**SHEARWATER-PAYNESVILLE
RESIDENTIAL DEVELOPMENT
EPBC ACT
REVIEW OF PRELIMINARY DOCUMENTATION
EPBC 2023/09592**

Figure 3.1: Drainage plans (eastern stormwater assets)

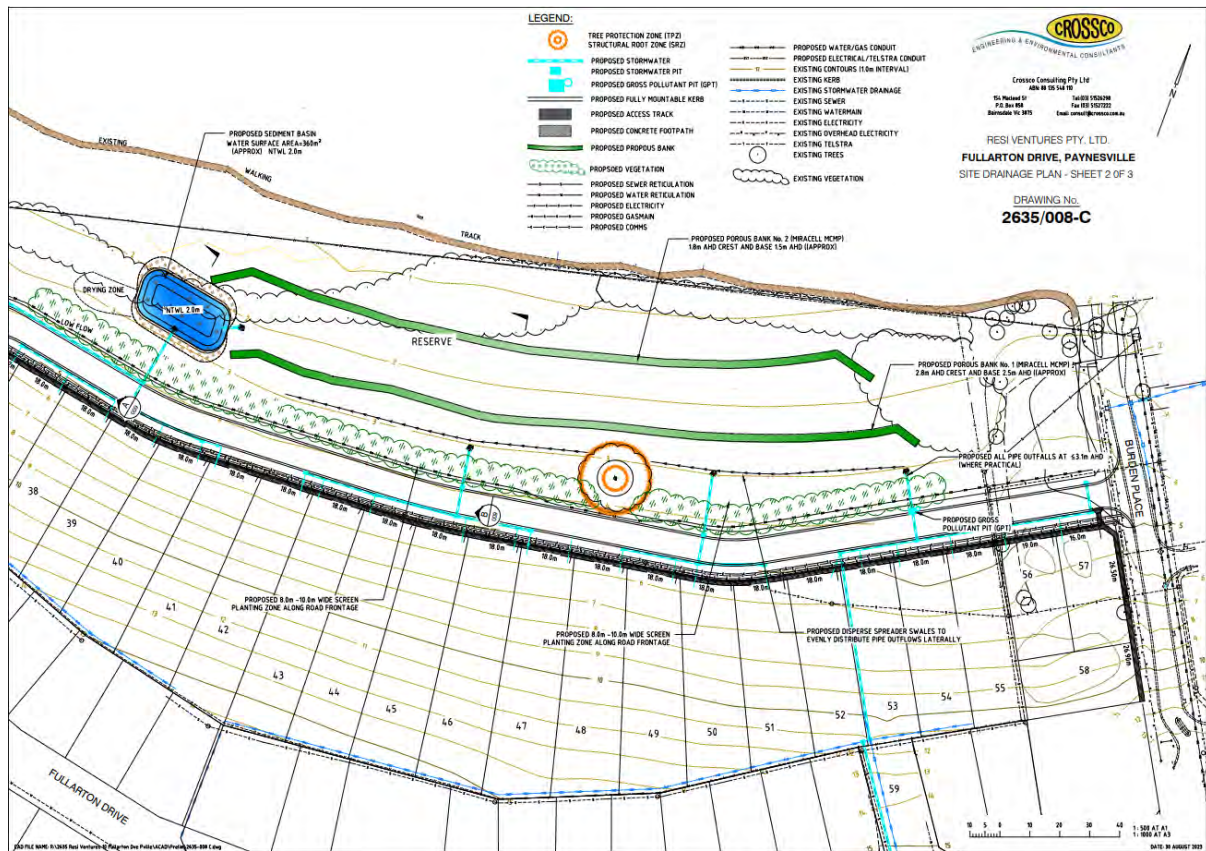
The porous filter banks (shown as two thick green lines in Figure 3.1) are referred to as a bioretention system in the Table A.5.3 (p.203) yet appear to be modelled as swales (see MUSIC schematic overleaf – swales circled in blue).

Both swales and bioretention systems differ significantly in their designs and are completely different to the porous bank design shown on the plans and described in the Neil Craigie report.

Figure 5.1: Sea Level Rise and Storm – Tide Surge extent by 2040

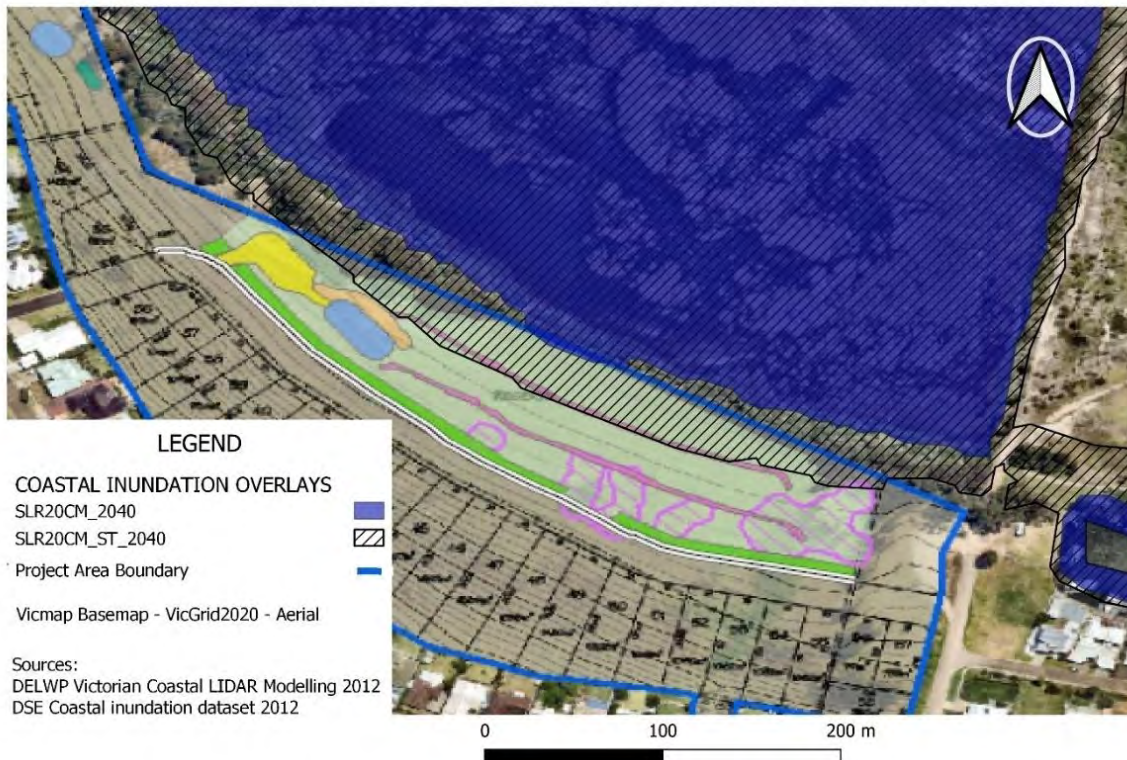
By the mid-21st century, sea-level rise of approximately 0.2–0.3 m is expected in the Gippsland Lakes. Though seemingly not a large rise in Lake levels, this is sufficient to almost completely inundate most of the Ramsar wetlands and bring the lake shoreline just into the project area itself (refer to figure 5.1). Mapping by the Victorian Department of Sustainability and Environment (DSE) shows that with 0.2 m Sea Level Rise (SLR), much of the project’s stormwater swale/bioretention area would lie within the storm/tide inundation zone (see Figure 5.1).

Figure 5.1(a): CROSSCO 2070 and 2100 Sea Level Rise and Storm – Tide Map

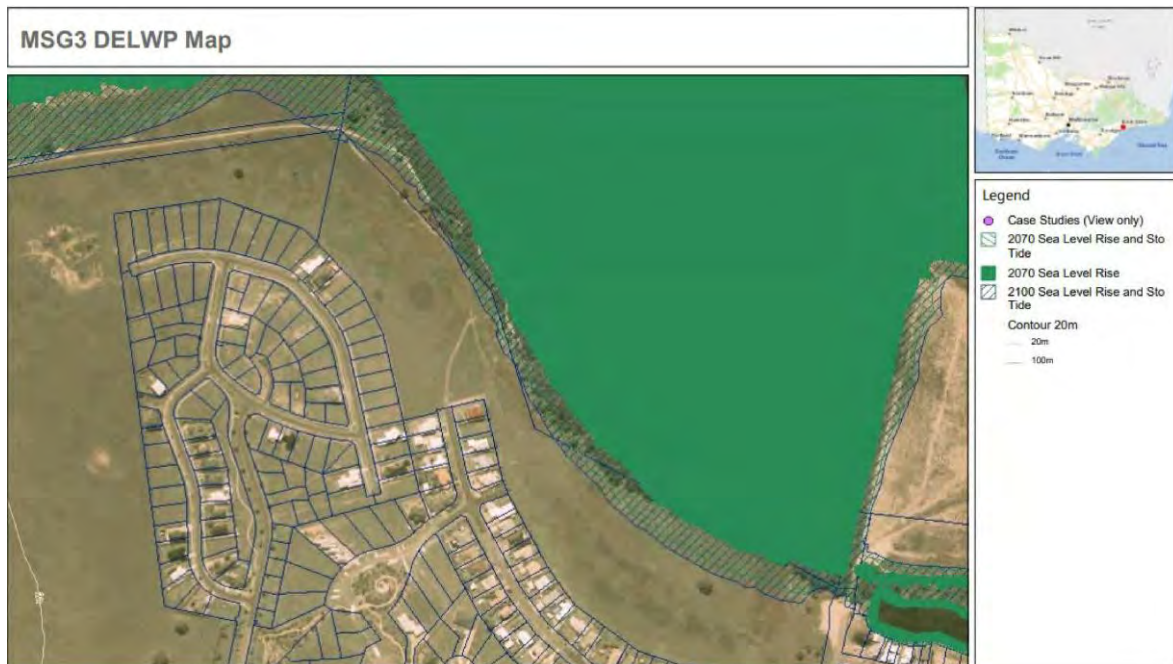
The CROSSCO map however does not show the placement of any municipal infrastructure, just the coastal inundation layers. The 2070 Sea Level Rise and Storm Tide layer is quite difficult to locate on the map, being largely obscured by the 2100 storm / tide layer overlaid on top. In order to substantiate the claim, we have reproduced just the 2070 ‘Future Coasts’ mapping layers and overlaid them on to a geo-referenced stormwater assets layer (refer to Figure 5.1(b) overleaf).

Figure 5.1(b): 2070 Sea Level Rise and Storm / Tide Surge and (East) Stormwater Assets

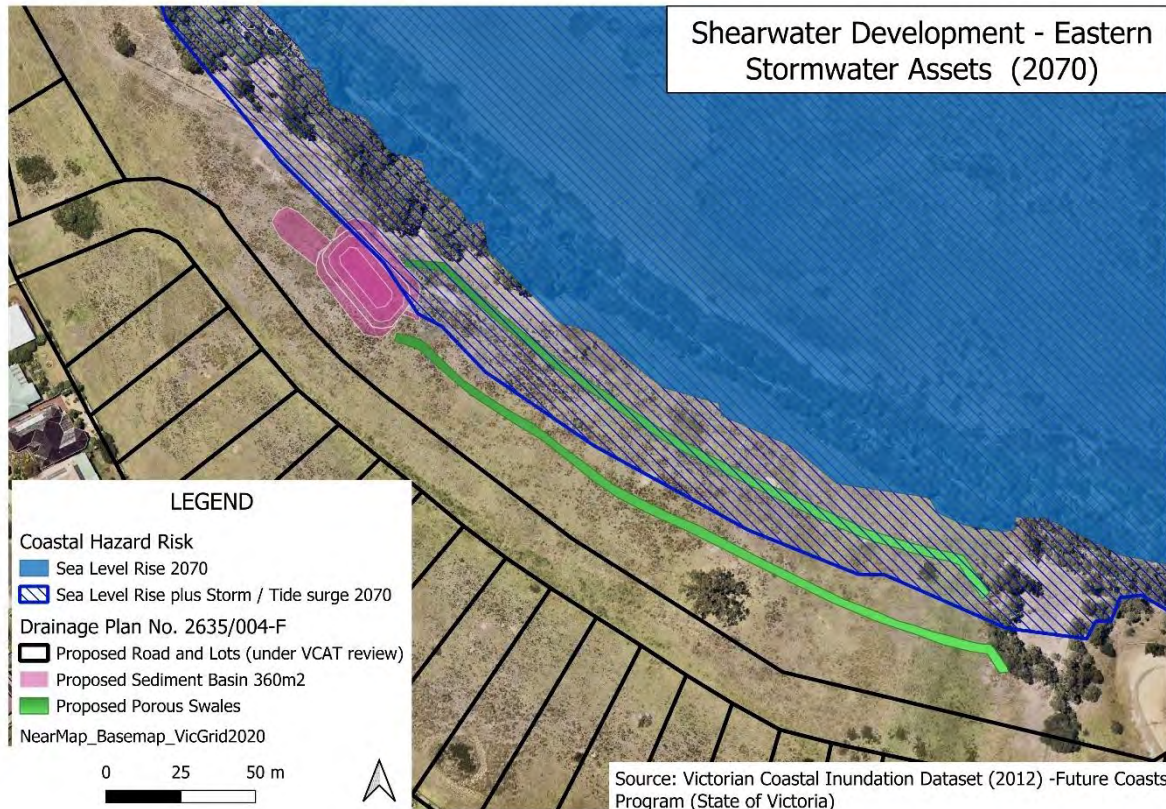
As is evident from the map shown in Figure 1(b), the eastern stormwater assets’ lowest porous bank will be impacted by storm and tide surges by 2070. This is even acknowledged in both the Water Technology and Neil Craigie correspondence, which formed part of the Preliminary Documentation (PD).

Likewise, the correspondence from Neil Craigie (p.4 / p.194) confirms that “the northernmost porous bank is proposed at an existing surface level of 1.5 m with its crest at 1.8 m. This is well above the expected impacts of sea level rise through the year 2070.” These statements confirm that **from the year 2070** the impacts of projected sea level rise and storm-induced erosion on the lower section of the proposed stormwater management system (SWMS)—including the associated Snipe habitat area—are not disputed. This stands in direct contrast to the CROSSCO report, which provides unsubstantiated assertions to the contrary.

Figure 7. Overlay Analysis: BirdLife East Gippsland's Latham's Snipe survey data compared to Nature Advisory's snipe habitat map

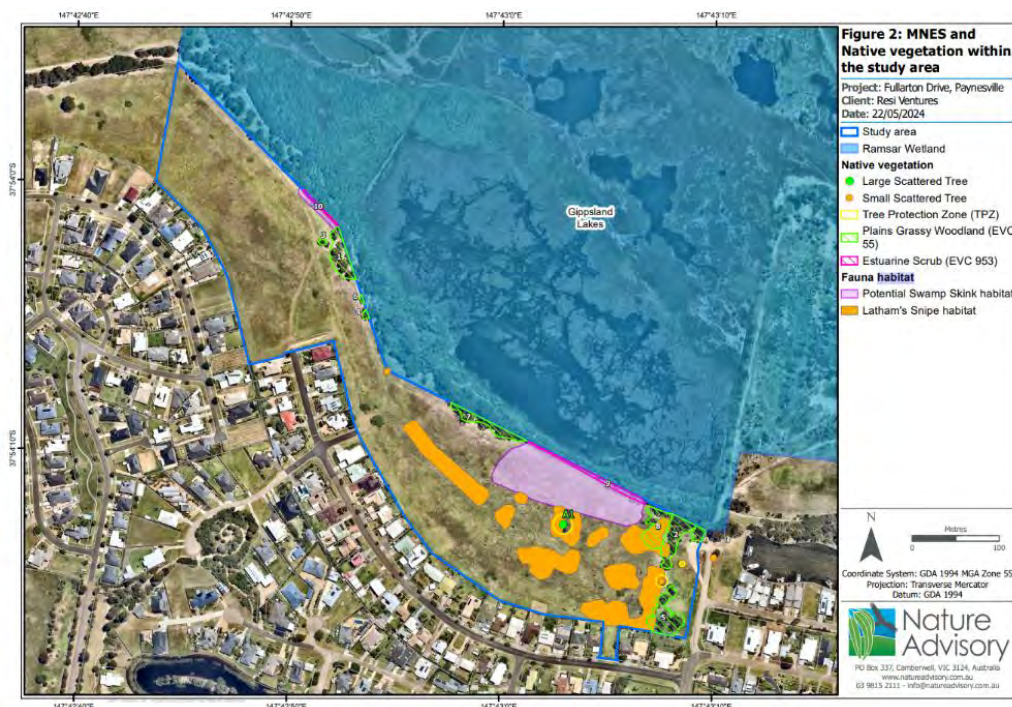
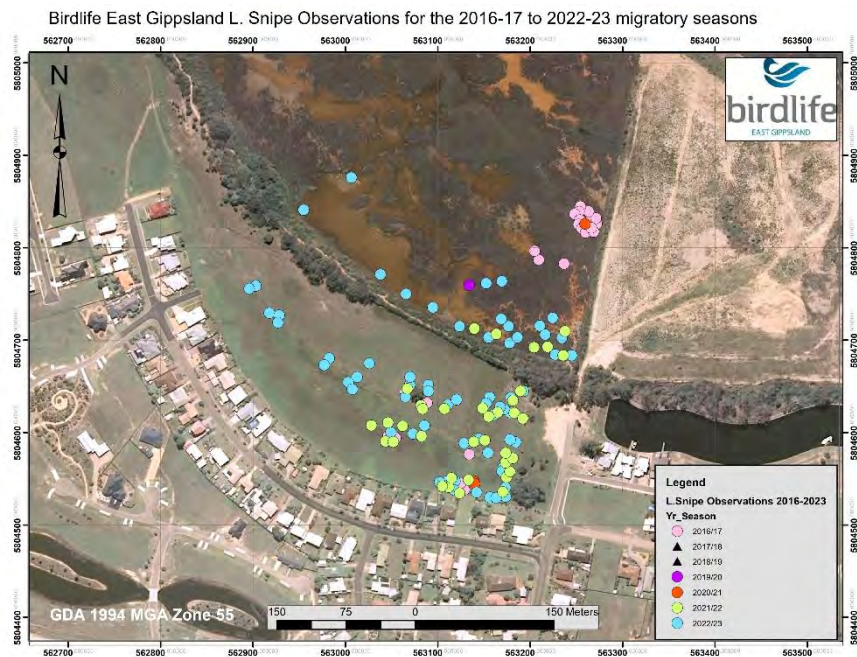
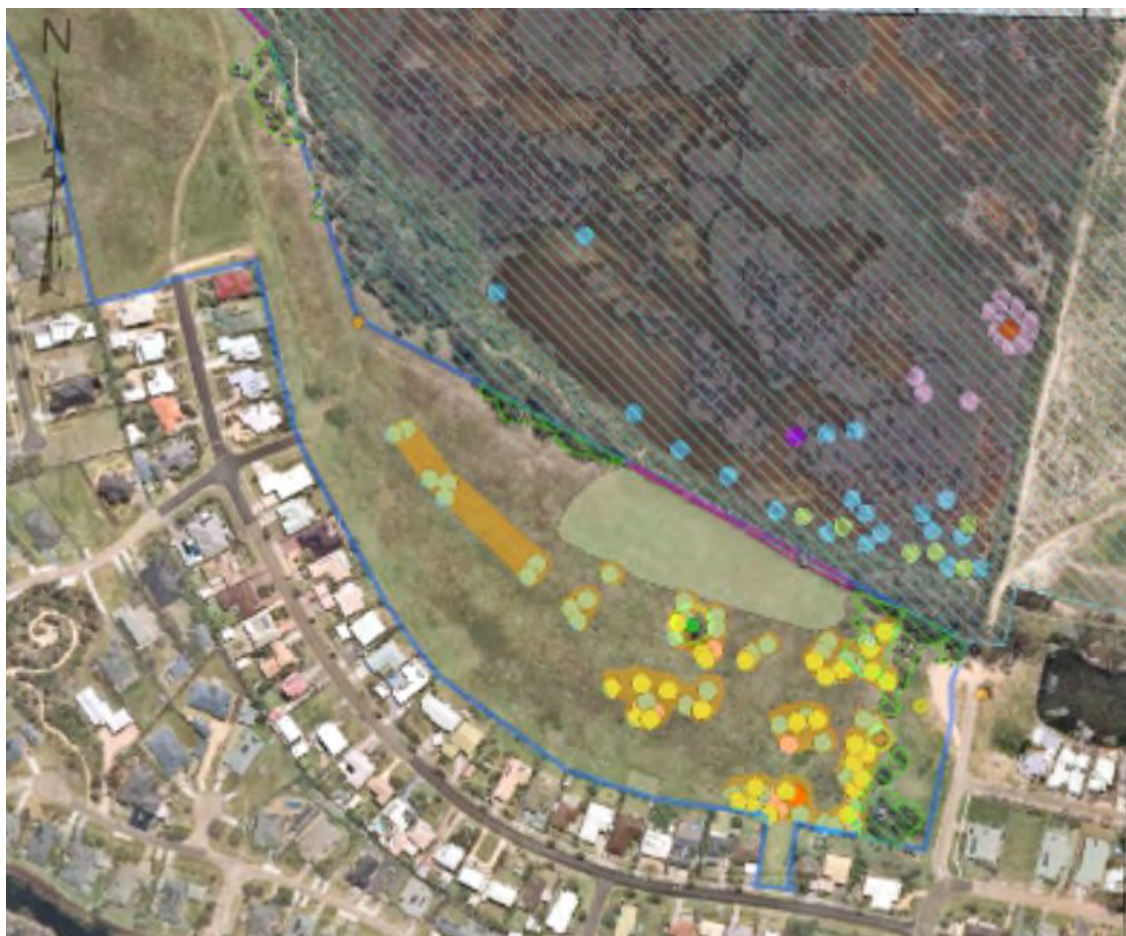
Flawed Snipe habitat mapping: Nature Advisory's map of Latham's Snipe habitat (Figure 5) and subsequent habitat area calculations, were largely derived from survey mapping data supplied by BirdLife East Gippsland (Figure 6). This is demonstrated by overlaying the BirdLife East Gippsland map of Latham's Snipe observations from 2016 to 2023 with Nature Advisory's mapped Latham's Snipe habitat (see Figure 7).

The incredibly close correlation between the BirdLife and Nature Advisory maps is unmistakable.

The key distinction between the two Snipe habitat maps is the inclusion, in the Nature Advisory version, of a linear extension of habitat along the underground sewage pipe that runs east–west through the eastern portion of the study area (refer to Figure 8). According to the referring party, “this underground pipe has impeded the downhill flow of water, and kept that section of ground damper than surrounding areas” (Referral, Section 4.1.5.2, p.20).

Figure 10: Biosis ecological features map showing Snipe locations (red/orange triangles)

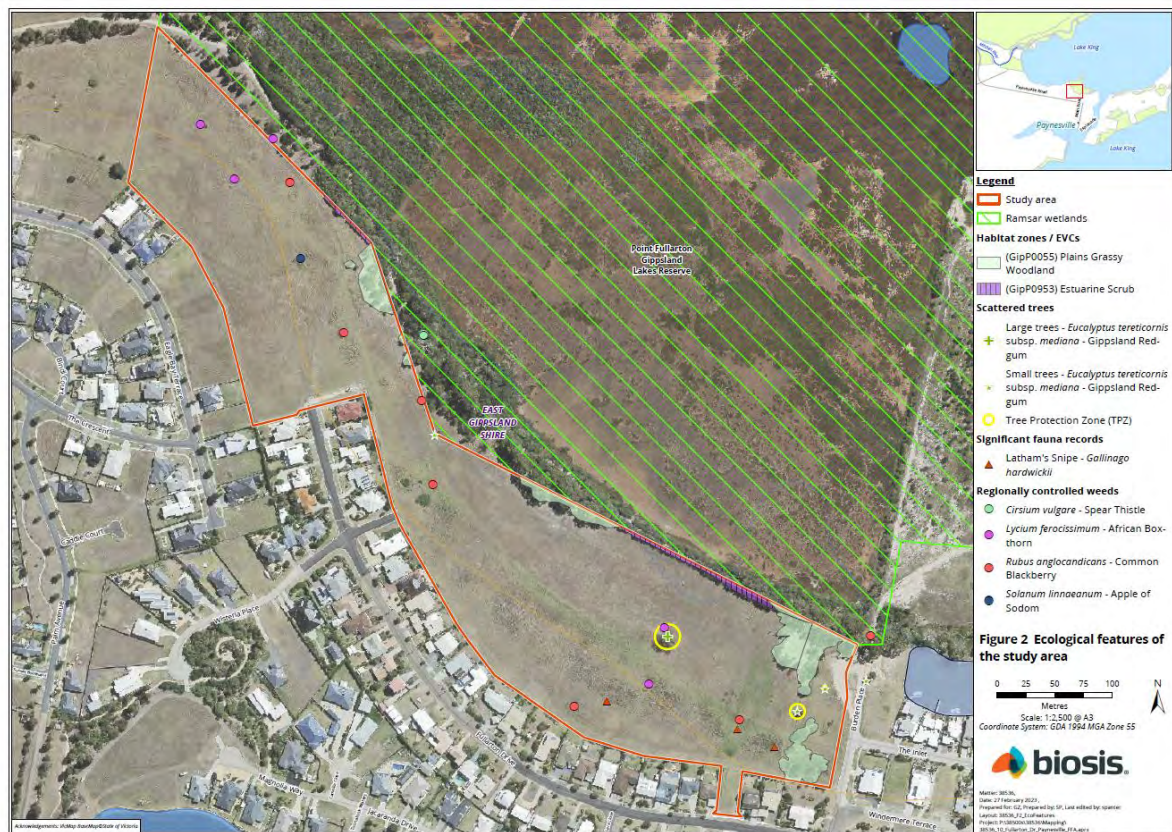
When overlaying both maps however, it appears Nature Advisory's Snipe habitat map omitted two of the three observations made by Biosis (see Figure 10 overleaf). The net effect of this and other omissions of ground surveyed Snipe locations is to **substantially underestimate** the actual Snipe habitat area on site.

Figure 11. Overlay Close-up: Comparing the Biosis and Nature Advisory maps shows two of three Latham's Snipe detections (orange triangles) not included in Nature Advisory's mapped habitat.

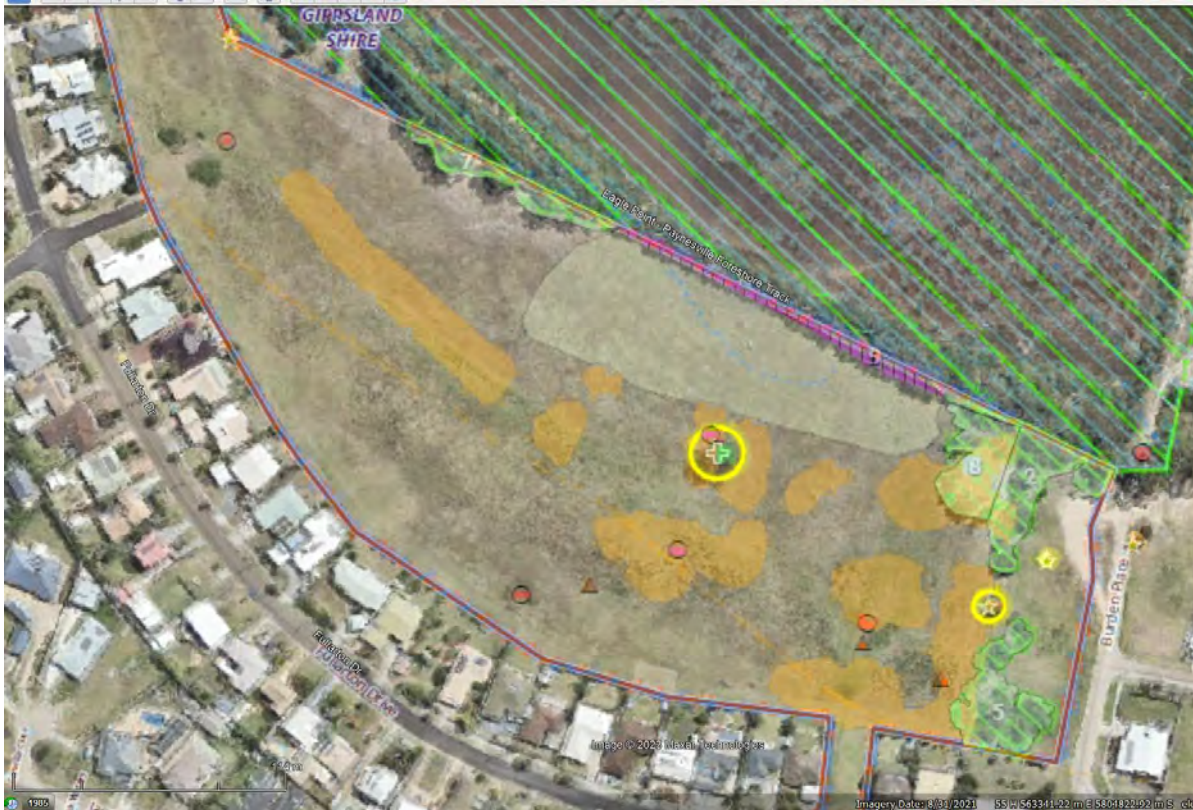
When overlaying both maps however, it appears Nature Advisory's Snipe habitat map omitted two of the three observations made by Biosis (see Figure 11). The net effect of this and other omissions of ground surveyed Snipe locations and potential habitat is to **substantially underestimate** the actual Snipe habitat area on site.
